The ISO received comments on the topics discussed at the March 14 stakeholder meeting from the following:

The following are the ISO's responses to the comments.

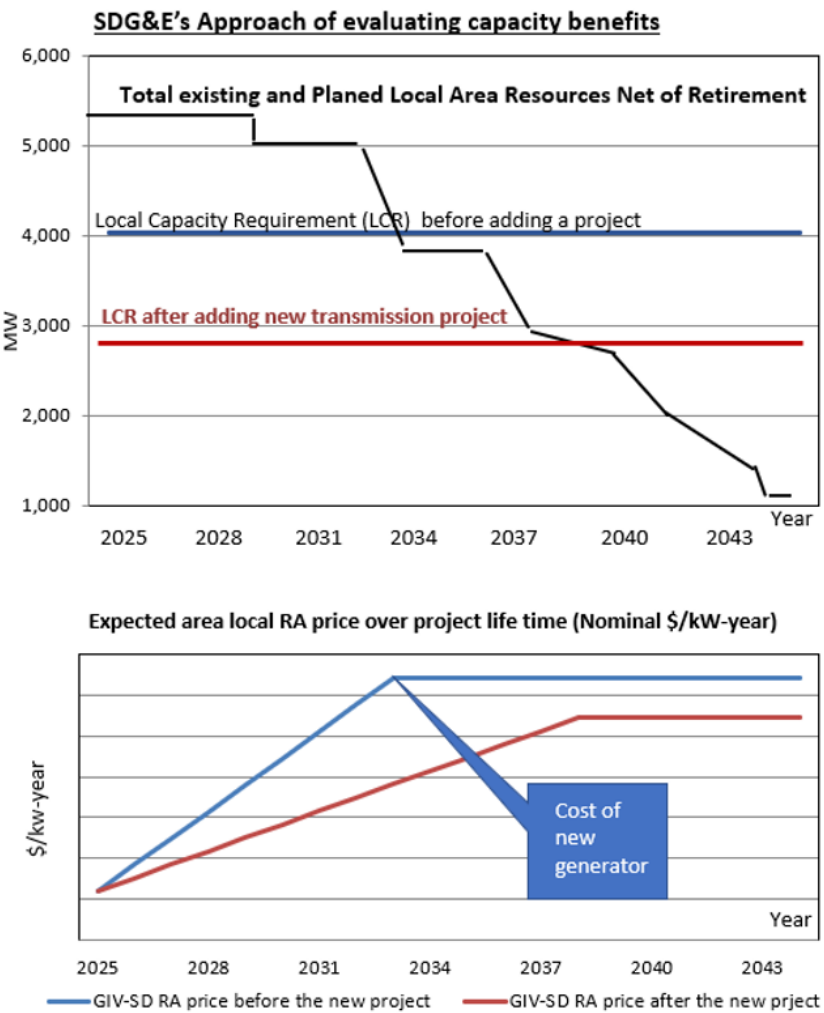
No	Comment Submitted	CAISO Response
	<p>future technology improvements on zero-carbon resources' costs (e.g. storage). The graph below illustrates such a methodology:</p> <p style="text-align: center;">SDG&E's Approach of evaluating capacity benefits</p>  <p>The first graph, titled 'Total existing and Planed Local Area Resources Net of Retirement', plots MW on the y-axis (1,000 to 6,000) against Year on the x-axis (2025 to 2043). It shows a black line for 'Total existing and Planed Local Area Resources Net of Retirement' which starts at approximately 5,300 MW in 2025 and decreases in steps to about 1,100 MW by 2043. A horizontal blue line at 4,000 MW is labeled 'Local Capacity Requirement (LCR) before adding a project'. A horizontal red line at approximately 2,800 MW is labeled 'LCR after adding new transmission project'. The black line crosses the blue line around 2034 and the red line around 2037.</p> <p>The second graph, titled 'Expected area local RA price over project life time (Nominal \$/kW-year)', plots \$/kW-year on the y-axis against Year on the x-axis (2025 to 2043). It shows a blue line for 'GIV-SD RA price before the new project' which rises to a peak around 2034 and then declines. A red line for 'GIV-SD RA price after the new prject' rises more gradually and levels off after 2037. A blue box labeled 'Cost of new generator' is positioned between the two lines from 2037 to 2040, indicating the period where the new project's cost is being evaluated against the RA price.</p> <p>SDG&E notes that important studies by the CAISO have been previously conducted using the approach proposed by SDG&E in these comments. SDG&E is unclear why, in the current transmission planning cycle, the CAISO</p>
